APPLICATION NO.	FILING DATE	FIRST NAMED INVENTOR	ATTORNEY DOCKET NO.	CONFIRMATION NO.
10/738,355	12/16/2003	Rodney J. Clements	10617	7570

## Office Action Summary

Claims 12-17, and 20-24 are rejected under 35 U.S.C. 102(b) as being anticipated by the Japanese patent, JP-2001-12070 (see marked-up attachment).

【図 1】

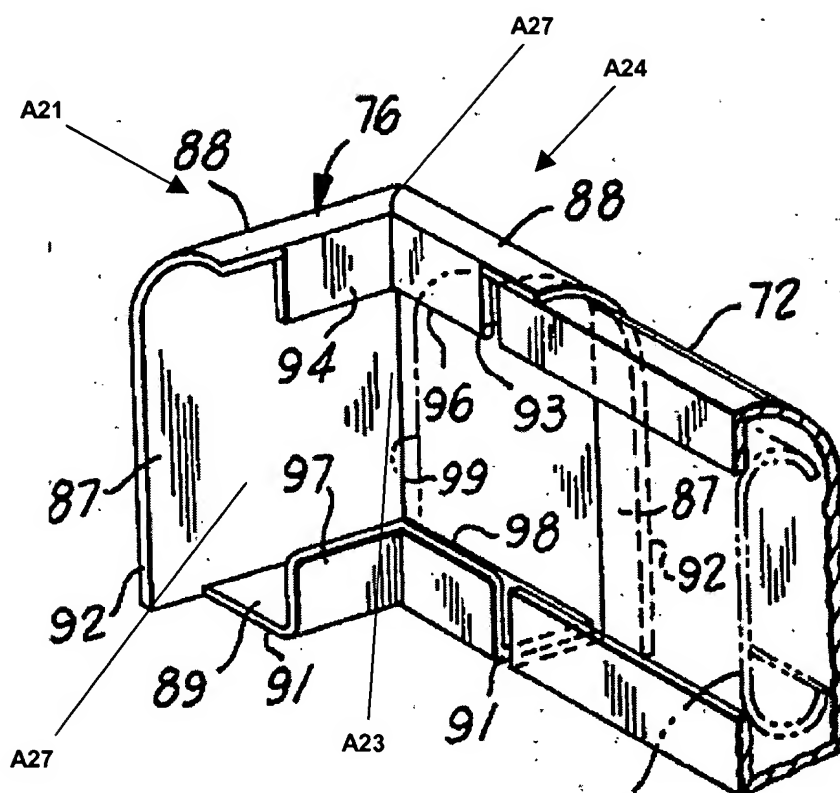
Regarding claim 12, the Japanese patent discloses, in Figure 1, a receptacle comprising a first receiver **A21**, a second receiver **A24**, and a juncture **A27**. The first receiver **A21** and the second receiver **A24** each have an open outer end **A22** and an inner end **A23**. The outer end **A22** of the first receiver **A21** includes an upper lip **2**, a lower trough **3**, and an inner wall **A3** therebetween. The outer end **A22** of the second receiver **A24** includes an upper lip **2**, a lower trough **3**, and a inner wall **A3** therebetween. The juncture **A27** is between the inner end **A23** of the first receiver **A21** and the inner end **A23** of the second receiver **A24**. The first receiver **A21** and the second receiver **A24** each have an internal cavity **A28** respectively extending from the outer end **A22** to the inner end **A23**. Applicant is reminded that the internal cavity **A28** is sized and configured snugly to accommodate and cover an end portion of a piece of molding or trim inserted therein.

Regarding claim 13, the juncture **A27** comprises an outside corner. The first receiver **A21** and the second receiver **A24** have axes maintained at 90 degrees, 120 degrees, or 135 degrees with respect to each other.

Regarding claim 14, the juncture **A27** comprising an inside corner. The first receiver **A21** and the second receiver **A24** each have an axis maintained at 90 degrees, 120 degrees, or 135 degrees with respect to each other (Fig. 4).

Regarding claims 15 and 21, the first receiver **A21** and the second receiver **A24** include retaining means **1**. Applicant is reminded that the retaining means **1** can secure molding or trim to the coupler without the use of fasteners or adhesives.

Regarding claims 16 and 22, the upper lip **2** includes an upwardly inclined section **A** extending to the inner wall **A3** and a vertical section **2a** extending downwardly along the inner wall **A3**. The lower trough **3** includes a horizontal section **3a** extending to the inner wall **A3** and a vertical section **3b** extending upwardly along the inner wall **A3**.

Regarding claims 17 and 23, the retaining means **1** comprises at least one rib extending along the inner wall **A3** of the first receiver **A21** and the second receiver **A24**.

Regarding claim 20, the Japanese patent discloses, in Figure 1, a receptacle comprising a first receiver **A21**, and a second receiver **A24**. The first receiver **A21** has an open outer end **A22** provided with an upper lip **2**, a lower trough **3**, and an inner wall **A3** therebetween. The second receiver **A24** has an open outer end **A22** provided with an upper lip **2**, a lower trough **3**, and an inner wall **A3** therebetween. The juncture **A27** is between the inner end **A23** of the first receiver **A21** and the inner end **A23** of the second receiver **A24**. The first receiver **A21** and the second receiver **A24** each have an internal cavity **A28** respectively extending from the outer end **A22** to the inner end **A23**. Applicant is reminded that the internal cavity **A28** is sized and configured snugly to accommodate and cover an end portion of a piece of molding or trim inserted therein.

Regarding claim 24, the Japanese patent discloses, in Figure 1, a receptacle comprising a first receiver **A21**, a second receiver **A24**, and a juncture **A27**. The first receiver **A21** and the second receiver **A24** each have an open outer end **A22** and an inner end **A23**. The outer end **A22** of the first receiver **A21** includes an upper lip **2**, a

Woods, 3,074,521

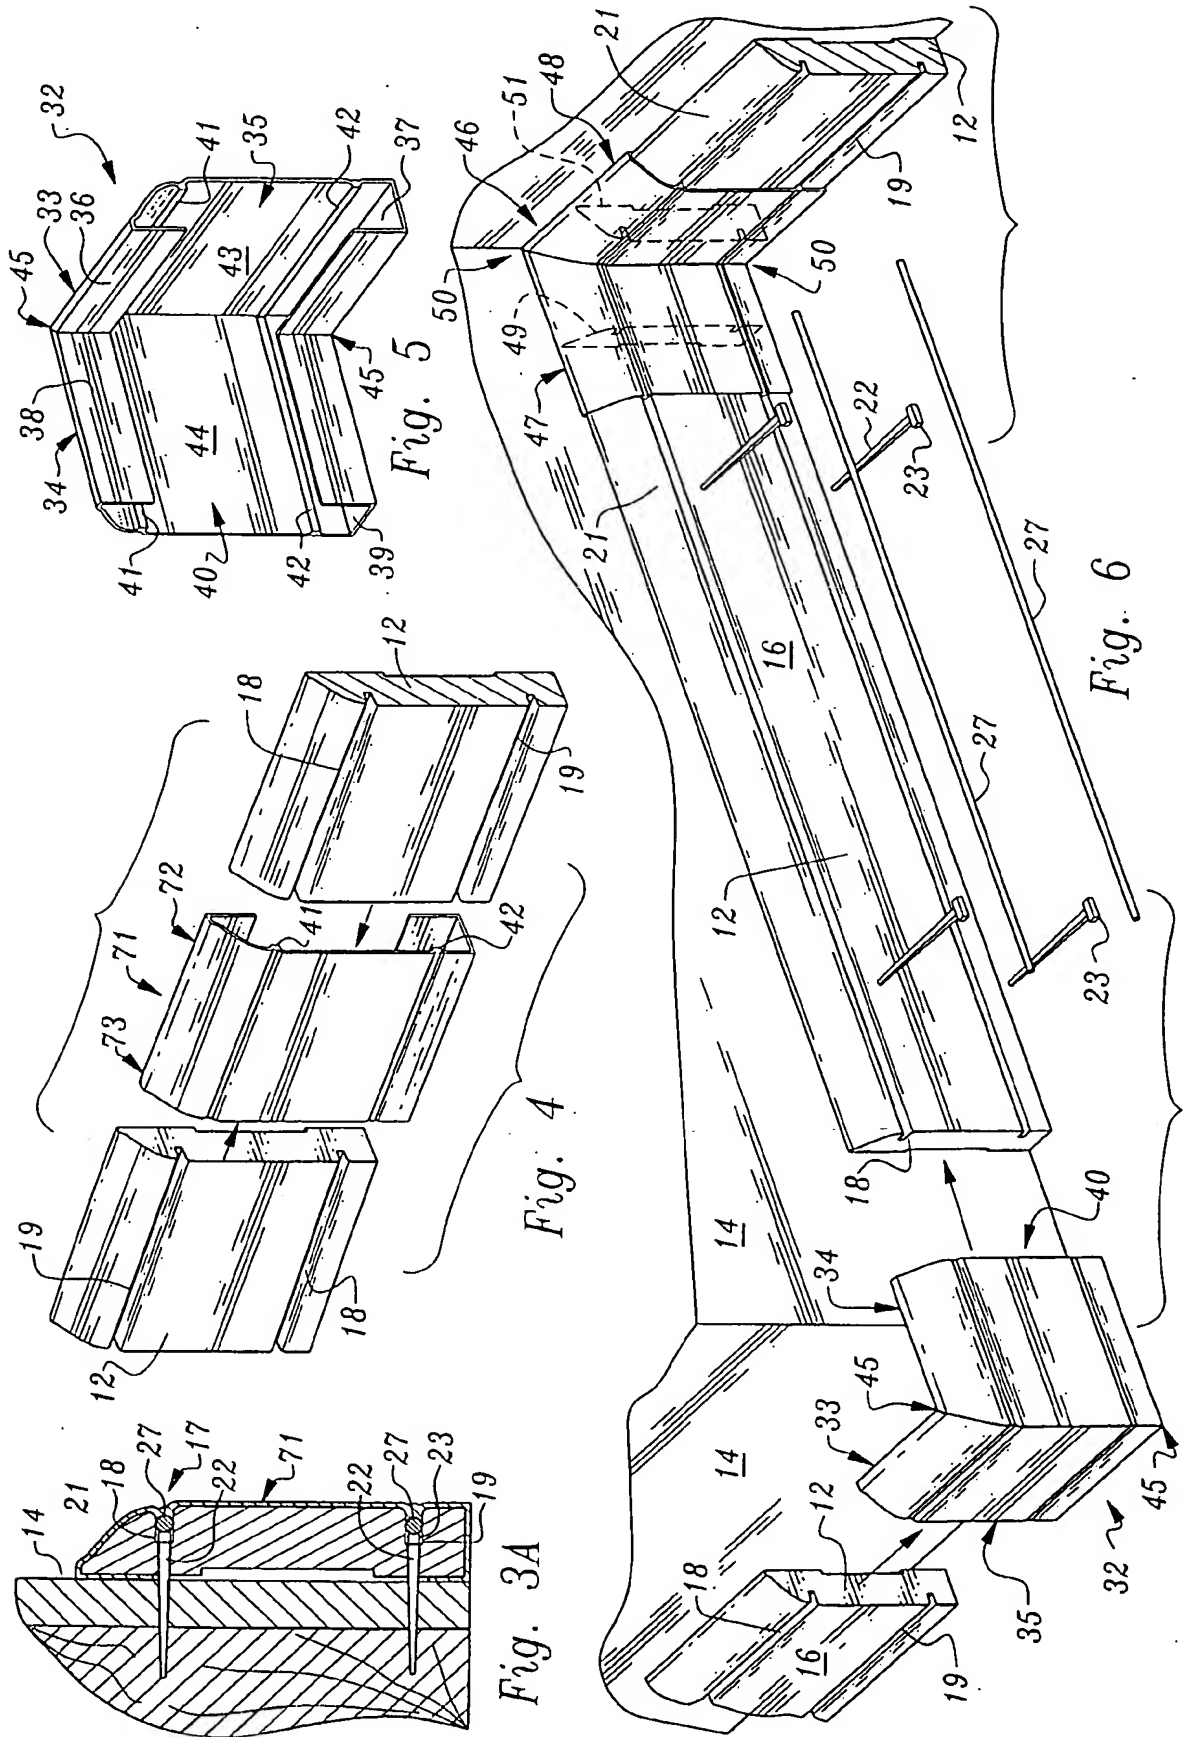
Regarding claim 12, Woods discloses, in Figure 10, a receptacle comprising a first receiver **A21**, a second receiver **A24**, and a juncture **A27**. The first receiver **A21** and the second receiver **A24** each have an open outer end **A22** and an inner end **A23**. The outer end **A22** of the first receiver **A21** includes an upper lip **93,95**, a lower trough **85,87**, and an inner wall **79,81** therebetween. The outer end **A22** of the second receiver **A24** includes an upper lip **93,95**, a lower trough **85,87**, and a inner wall **79,81**

Regarding claim 13, the juncture **A27** comprises an outside corner. The first receiver **A21** and the second receiver **A24** have axes maintained at 90 degrees, 120 degrees, or 135 degrees with respect to each other.

Regarding claims 15 and 21, the first receiver **A21** and the second receiver **A24** include retaining means **89,91**. Applicant is reminded that the retaining means **89,91** can secure molding or trim to the coupler without the use of fasteners or adhesives.

Regarding claim 18, the first receiver **A21** and the second receiver **A24** define respective planes which are oblique with respect to each other. Applicants should note that "substantially at a 270 degrees" as defined in column 5, line 38 allows for variation

Regarding claim 20, Woods discloses, in Figure 10, a receptacle comprising a first receiver **A21**, and a second receiver **A24**. The first receiver **A21** has an open outer end **A22** provided with an upper lip **93,95**, a lower trough **85,87**, and an inner wall **79,81** therebetween. The second receiver **A24** has an open outer end **A22** provided with an upper lip **93,95**, a lower trough **85,87**, and an inner wall **79,81** therebetween. The juncture **A27** is between the inner end **A23** of the first receiver **A21** and the inner end **A23** of the second receiver **A24**. The first receiver **A21** and the second receiver **A24** each have an internal cavity **A28** respectively extending from the outer end **A22** to the inner end **A23**. Applicant is reminded that the internal cavity **A28** is sized and configured snugly to accommodate and cover an end portion of a piece of molding or trim inserted therein.

Regarding claim 24, Woods discloses, in Figure 10, a receptacle comprising a first receiver **A21**, a second receiver **A24**, and a juncture **A27**. The first receiver **A21** and the second receiver **A24** each have an open outer end **A22** and an inner end **A23**. The outer end **A22** of the first receiver **A21** includes an upper lip **93,95**, a lower trough **85,87**, and an inner wall **79,81** therebetween. The outer end **A22** of the second receiver **A24** includes an upper lip **93,95**, a lower trough **85,87**, and an inner wall **79,81** therebetween. The juncture **A27** is between the inner end **A23** of the first receiver **A21** and the inner end **A23** of the second receiver **A24**. The first receiver **A21** and the second receiver **A24** each have an internal cavity **A28** respectively extending from the outer end **A22** to the inner end **A23**. Applicants are reminded that the internal cavity **A28** is sized and configured snugly to accommodate and cover an end portion of a piece of molding or trim inserted therein.

*Fig. 9*

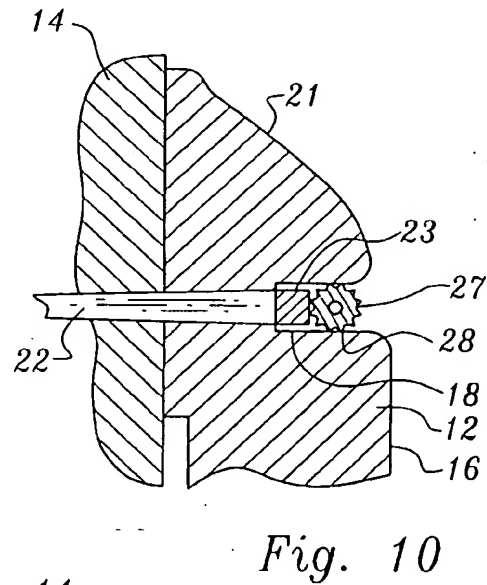
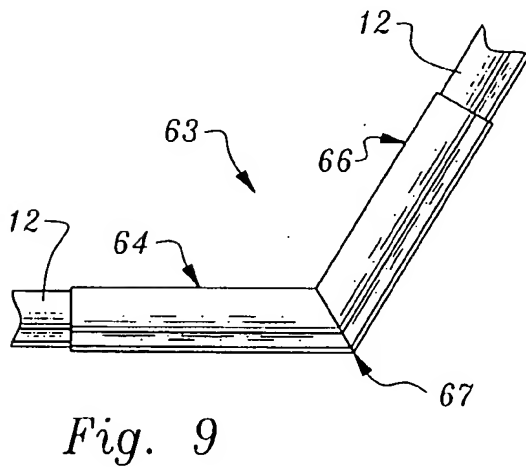
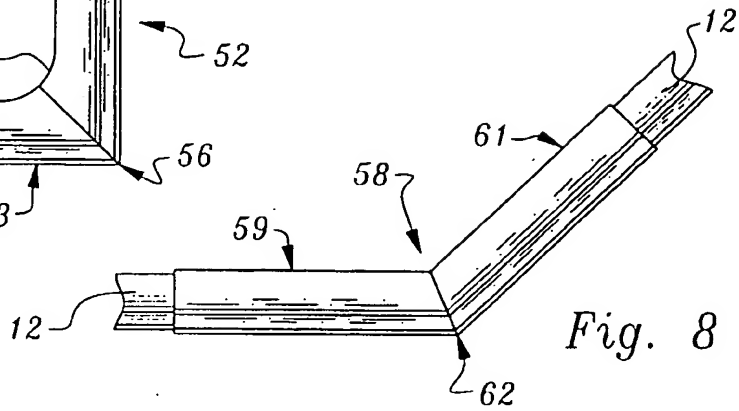
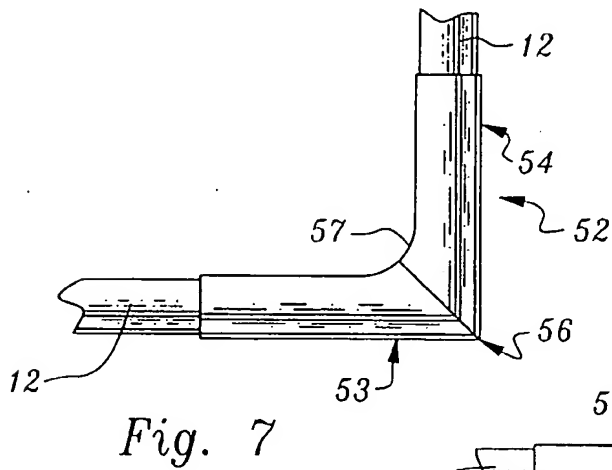
Regarding claim 12, Gooding discloses, in Figure 9, a receptacle comprising a first receiver **A21**, a second receiver **A24**, and a juncture **A27**. The first receiver **A21** and the second receiver **A24** each have an open outer end **91** and an inner end **A23**. The outer end **91** of the first receiver **A21** includes an upper lip **88,94**, a lower trough **89,91**, and an inner wall **87** therebetween. The outer end **91** of the second receiver **A24** includes an upper lip **88,94**, a lower trough **89,91**, and an inner wall **87** therebetween. The juncture **A27** is between the inner end **A23** of the first receiver **A21** and the inner end **A23** of the second receiver **A24**. The first receiver **A21** and the second receiver **A24** each have an internal cavity **A28** respectively extending from the outer end **91** to the inner end **A23**. Applicant is reminded that the internal cavity **A28** is sized and configured snugly to accommodate and cover an end portion of a piece of molding or trim inserted therein.

Regarding claims 16 and 22, the upper lip **88,94** includes an upwardly inclined section **88** extending to the inner wall **87** and a vertical section **94** extending

downwardly along the inner wall **87**. The lower trough **89,91** includes a horizontal section **89** extending to the inner wall **87** and a vertical section **97** extending upwardly along the inner wall **87**.

Regarding claim 20, Gooding discloses, in Figure 9, a receptacle comprising a first receiver **A21**, and a second receiver **A24**. The first receiver **A21** has an open outer end **91** provided with an upper lip **88,94**, a lower trough **89,91**, and an inner wall **87** therebetween. The second receiver **A24** has an open outer end **91** provided with an upper lip **88,94**, a lower trough **89,91**, and an inner wall **87** therebetween. The juncture **A27** is between the inner end **A23** of the first receiver **A21** and the inner end **A23** of the second receiver **A24**. The first receiver **A21** and the second receiver **A24** each have an internal cavity **A28** respectively extending from the outer end **91** to the inner end **A23**. Applicant is reminded that the internal cavity **A28** is sized and configured snugly to accommodate and cover an end portion of a piece of molding or trim inserted therein.
